HISTORIC AND DESIGN REVIEW COMMISSION February 01, 2017 Agenda Item No: 11

HDRC CASE NO: ADDRESS: LEGAL DESCRIPTION: ZONING: CITY COUNCIL DIST.: DISTRICT: APPLICANT: OWNER: TYPE OF WORK: 2016-522 841 E GUENTHER ST NCB 2917 BLK 6 LOT E IRR 67 FT OF S 43.43 FT OF 11 RM-4,H,RIO-4 1 King William Historic District Carlos Villarreal Carlos Villarreal Exterior modifications, hardscaping, addition

The applicant is requesting conceptual approval to perform exterior modifications to the primary historic structure including altering each elevation, the height and roof form.

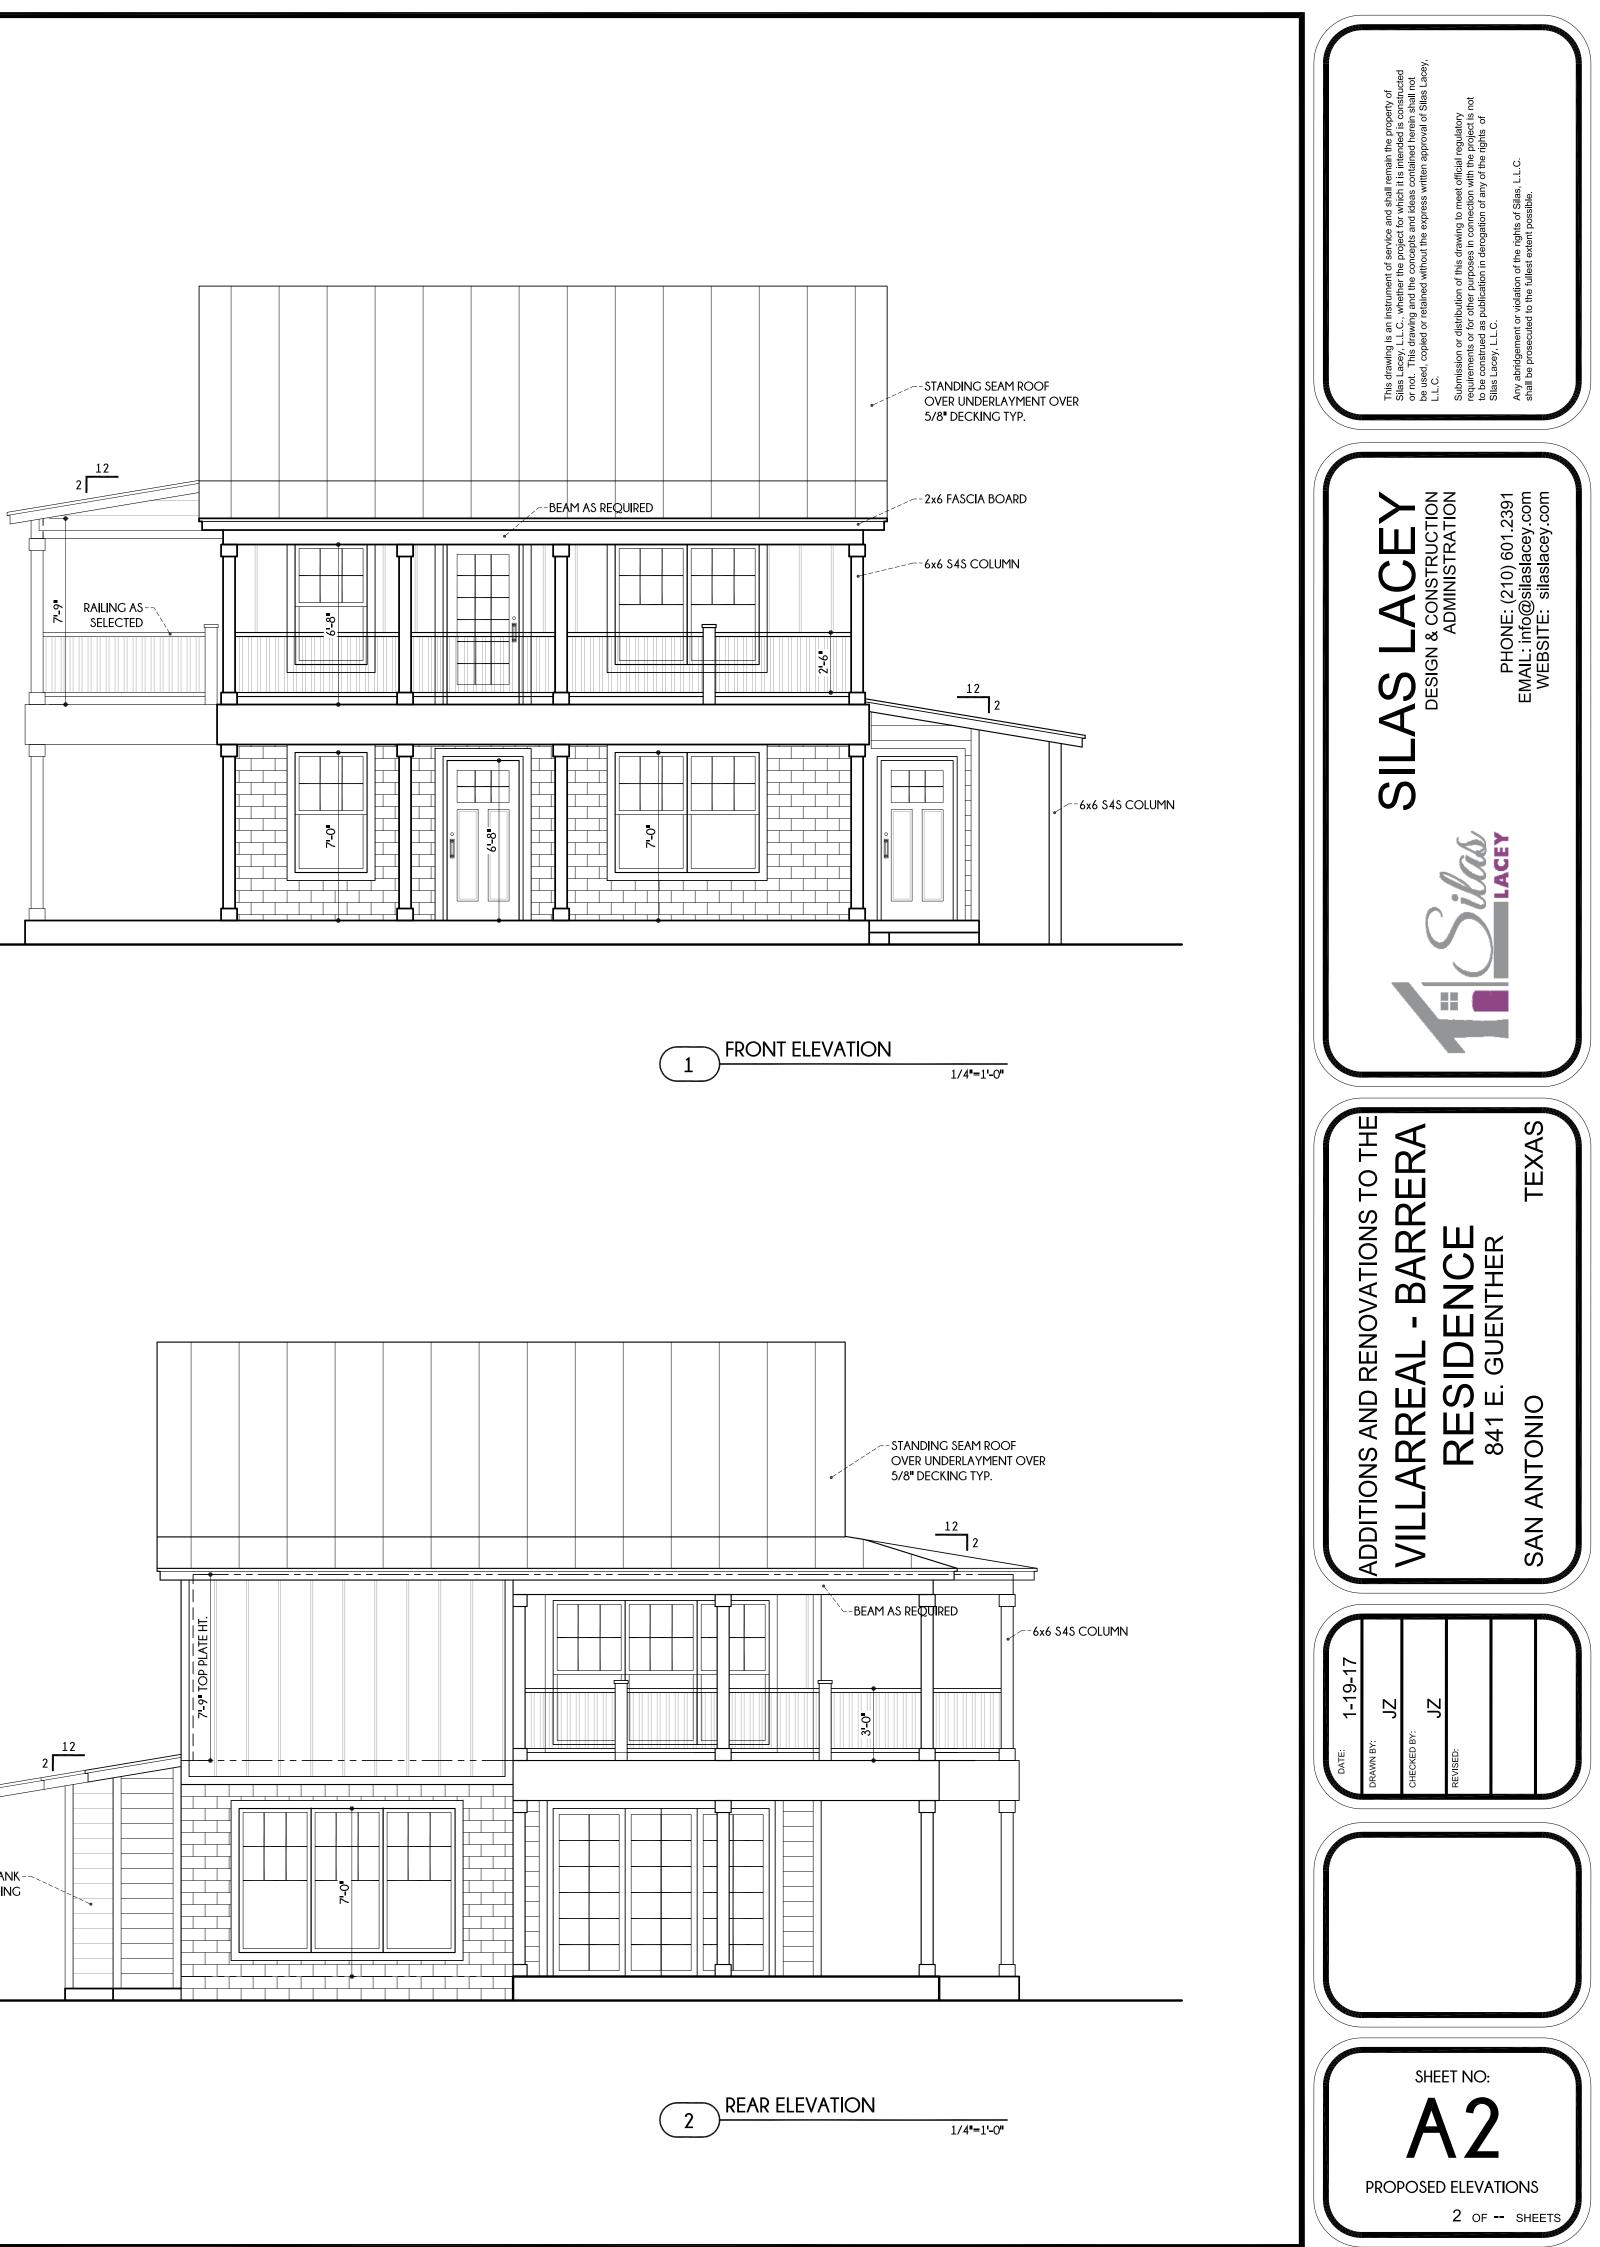
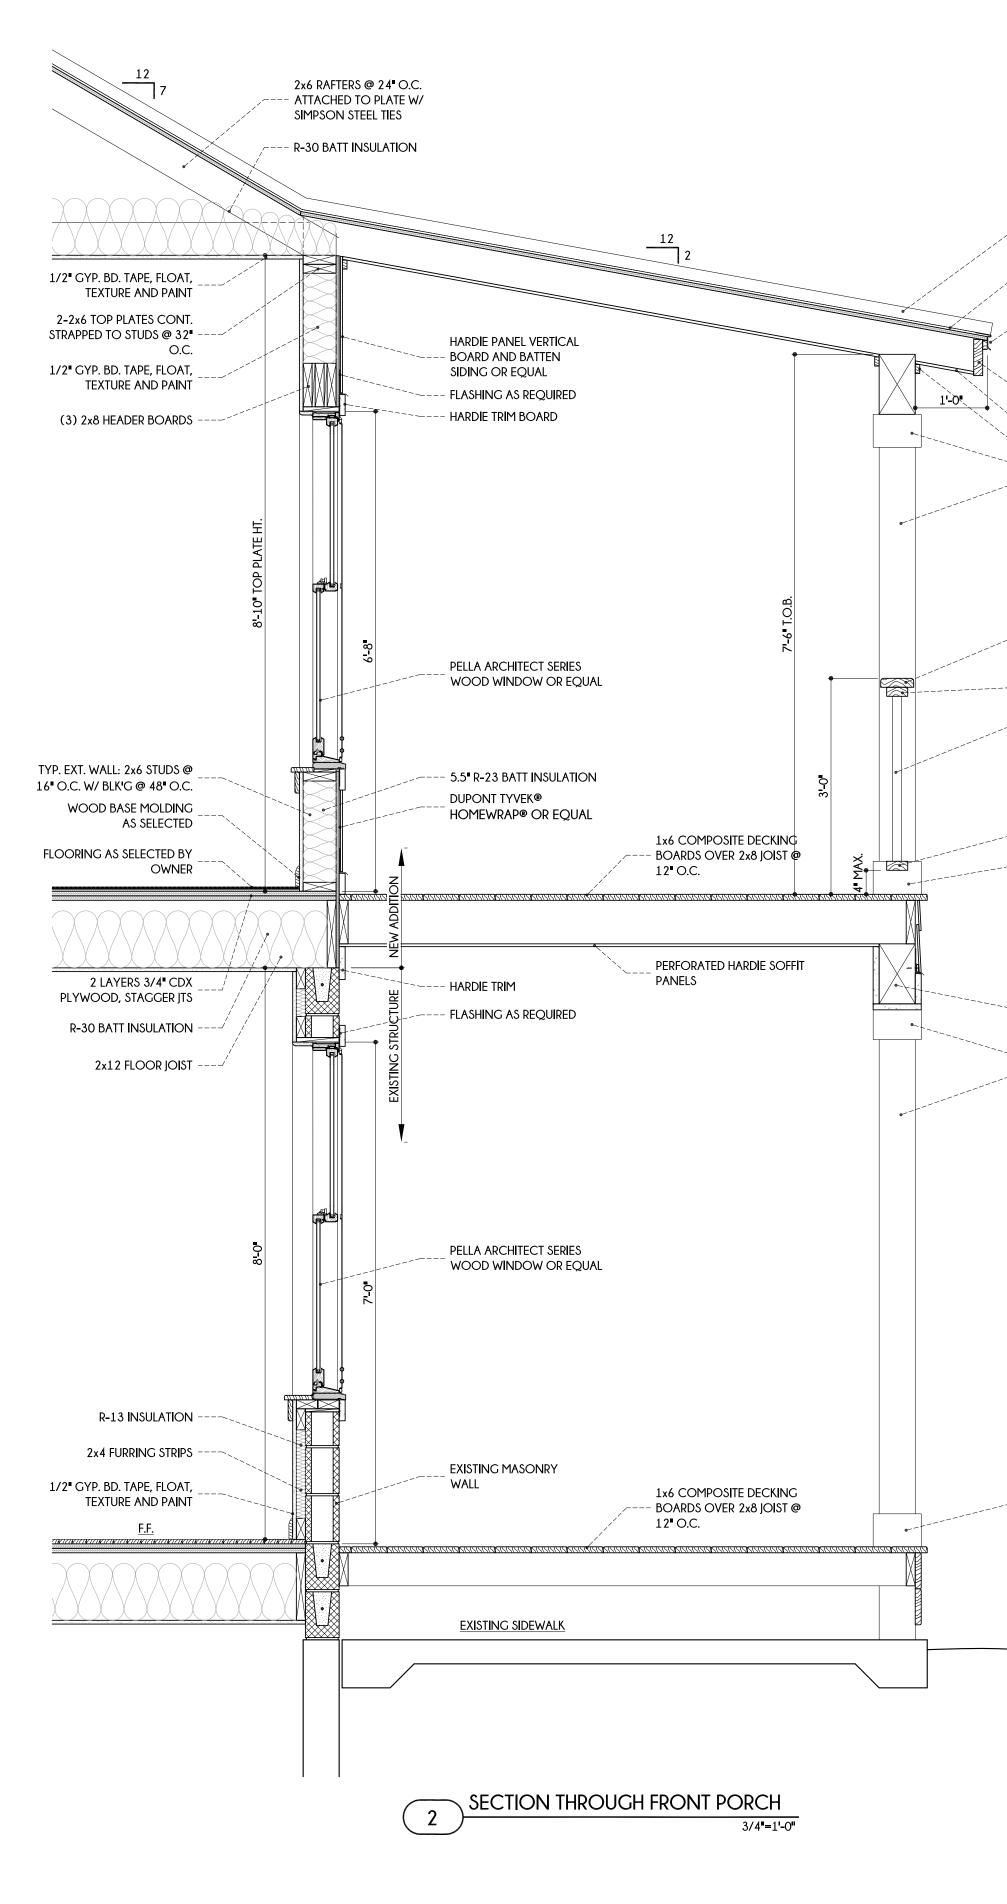
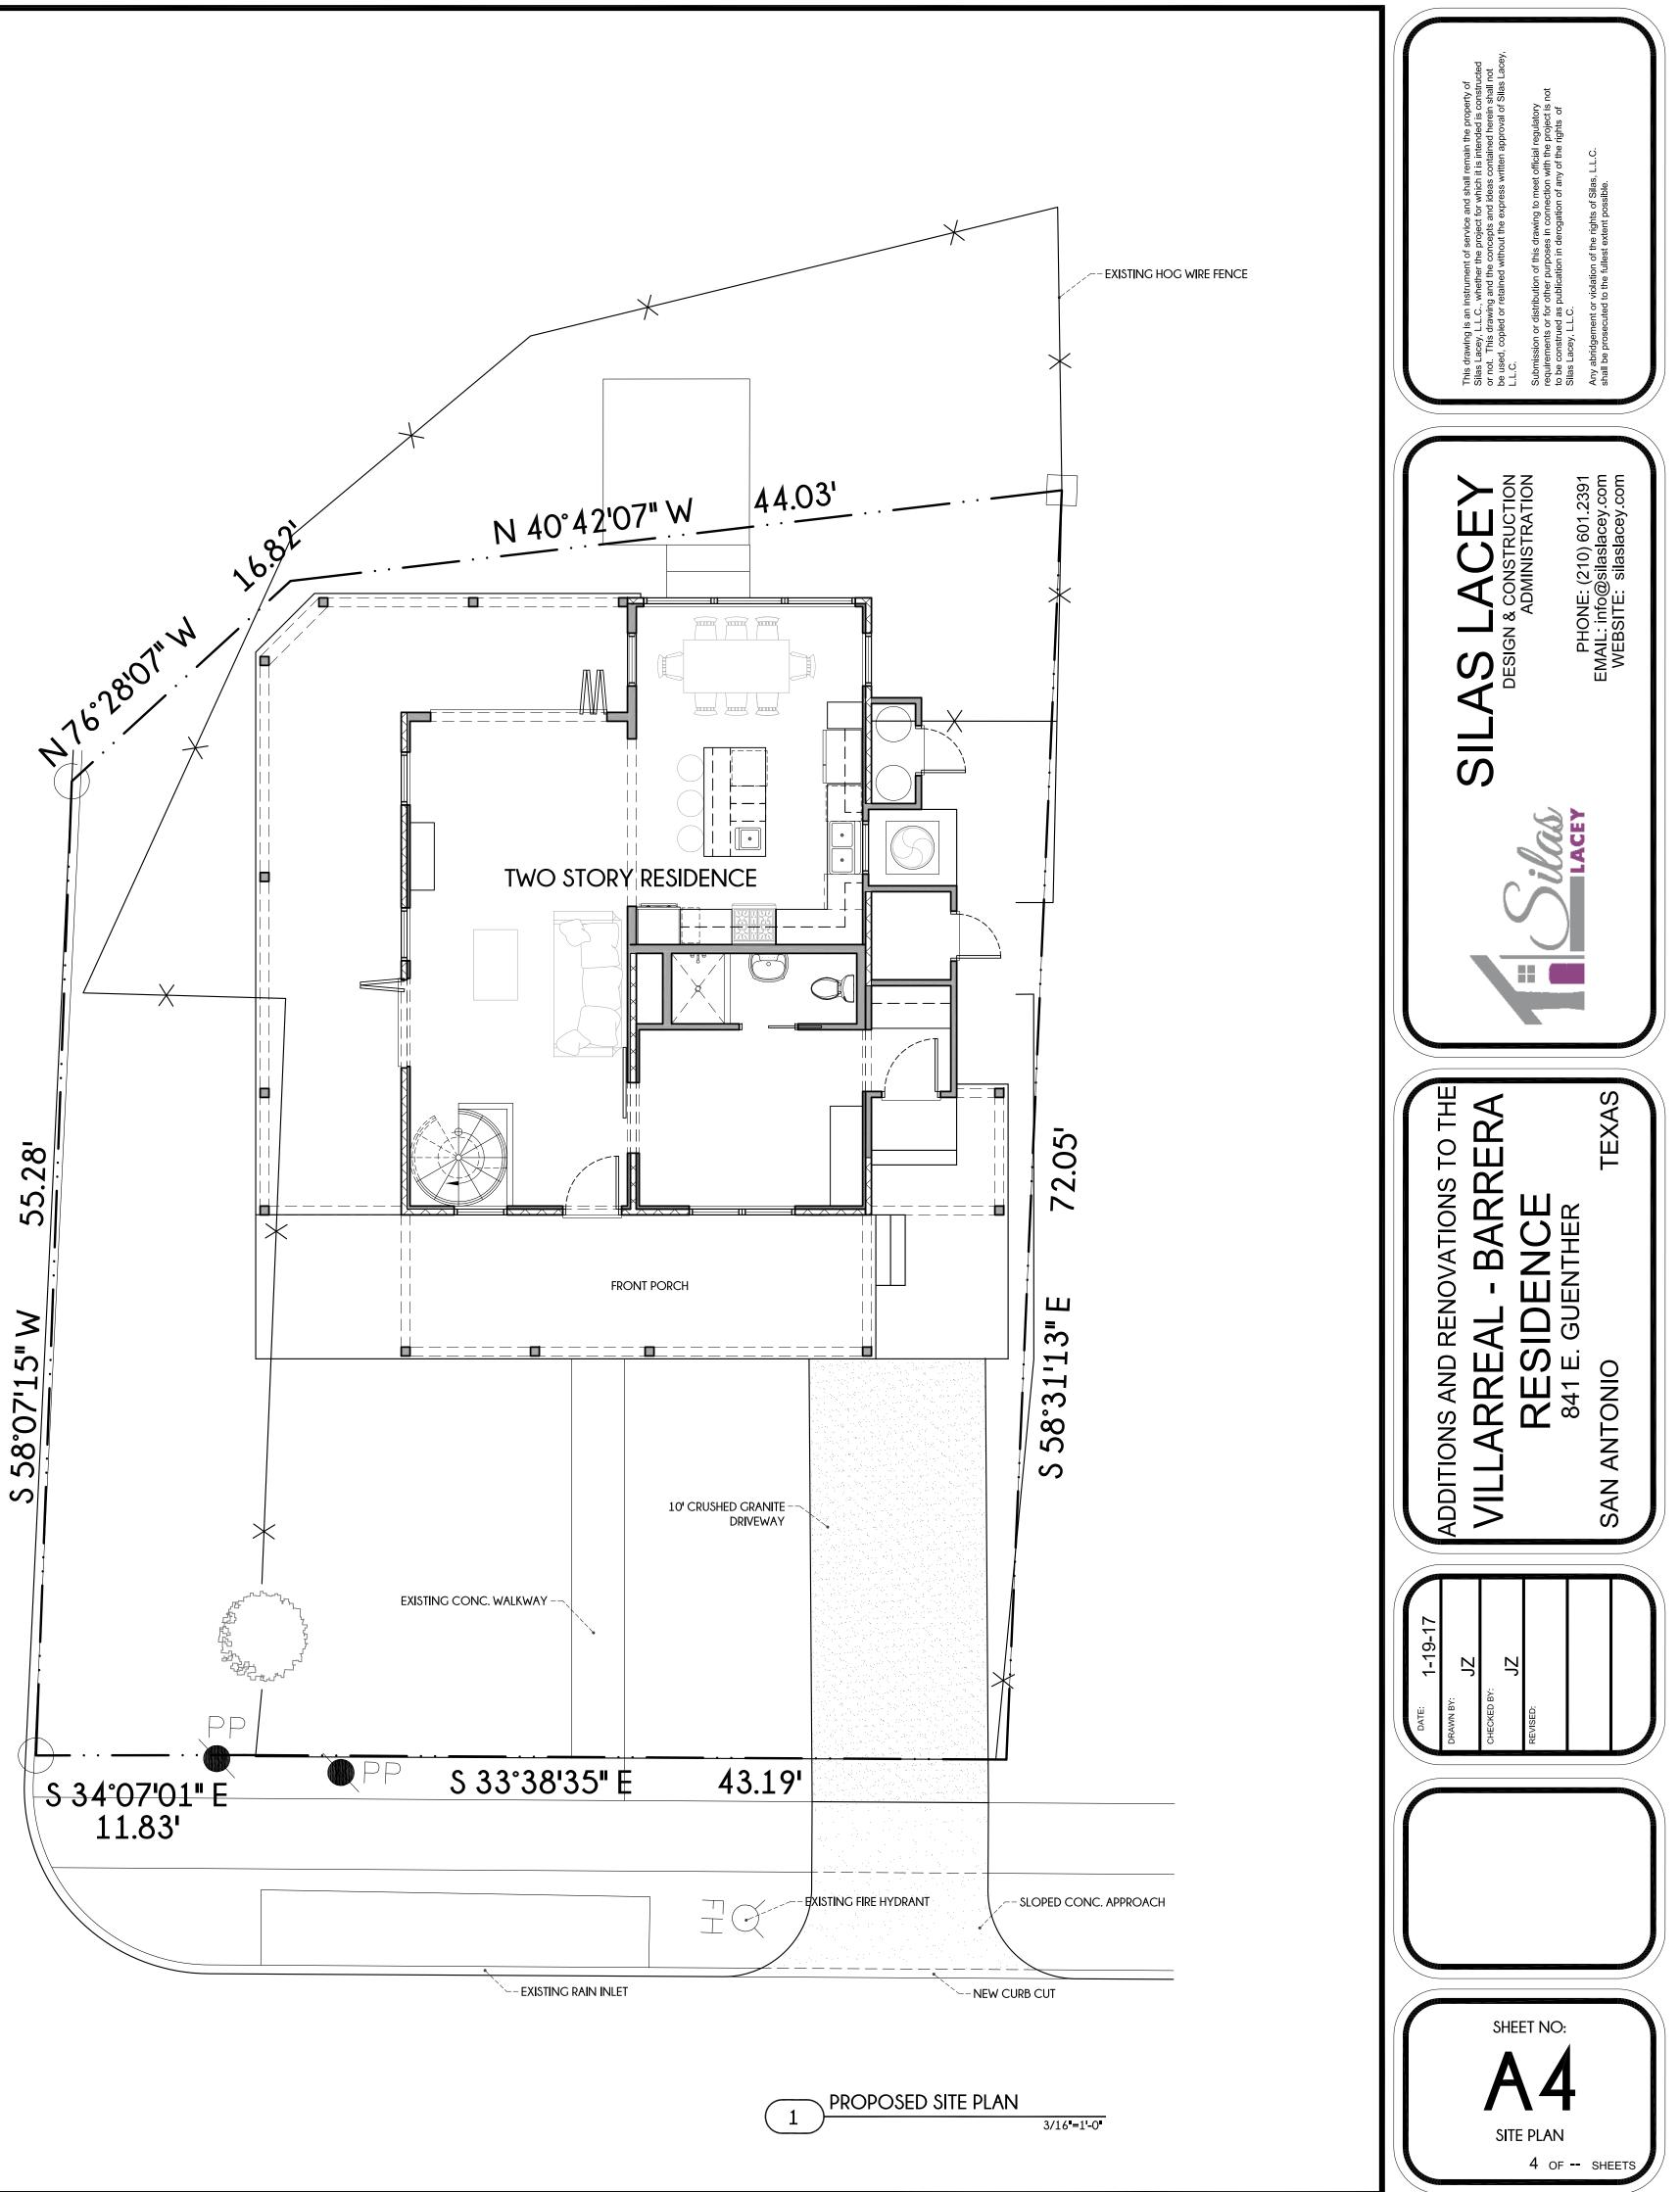
COMMENTS/CONCERNS: Mo: QUESTIONS DEGARDING PROPOSED MATERIALS. M.G. IN THE PROPOSED ABJOND; CONCERN WAS WITH THE PROPOSED MODIFIED MADELING DORMERS. THE LURDENT DESIGN DOES NOT PRATURE THIS ISSUE. JL: THE PROPOSED NEW DESIGN IS SIGNIFICANTLY IMPROVED OVER THE PREVIOUS DESIGN. MG: ALL COLUMNS NEED SOME DEFINITION; LAPITALS AND BASES ARE NEEDED - GXG ALMENSION IS APPROPRIATE.
